**SUBJECT: REDEFINITION OF FULLY WITHDRAWN (TAC NOS. 71834/71835)**

**RE: SALEM GENERATING STATION, UNIT NOS. 1 AND 2**

Amendment No. 91  
License No. DPR-70

Amendment No. 66  
License No. DPR-75

Figure 3.1-1  
 ROD BANK INSERTION LIMITS VERSUS THERMAL POWER  
 FOUR LOOP OPERATION

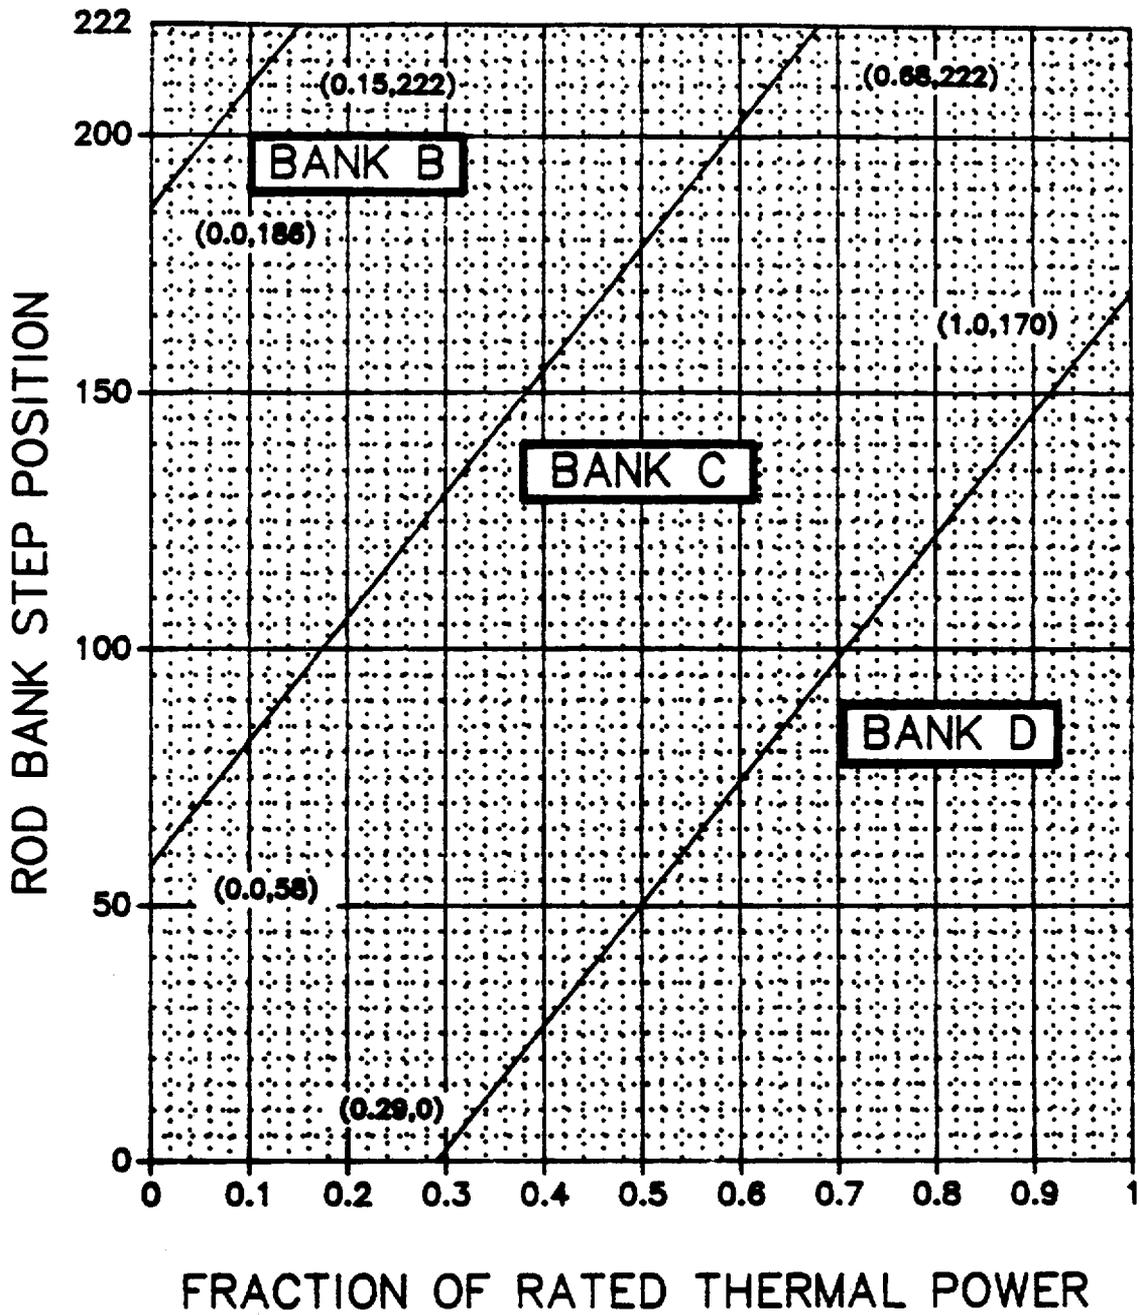
These amendments redefine the FULLY WITHDRAWN position of the control rod cluster assemblies from 228 steps to a band between 222 and 228 steps withdrawn. Other changes: delete Figure 3.1.2 from Unit 1 TSs; delete Specification 3.10.5 from Unit 2 TSs; and incorporate rod testing requirements into Specification 3.1.3.2.2 for Unit 1 and Unit 2 TSs.

Figure 3.1.2 in the Salem 1 Technical Specifications (TSs) provides the Rod Bank Insertion Limits versus Thermal Power for three-loop operation. Operation of Salem 1 with less than 4-loops has not been approved. Therefore, the licensee has proposed to delete Figure 3.1.2 from the Salem 1 TSs rather than modifying the curve to reflect the redefinition of FULLY WITHDRAWN. The staff finds this proposed change to be acceptable.

INTENTIONALLY LEFT BLANK PENDING  
COMMISSION APPROVAL OF THREE LOOP OPERATION
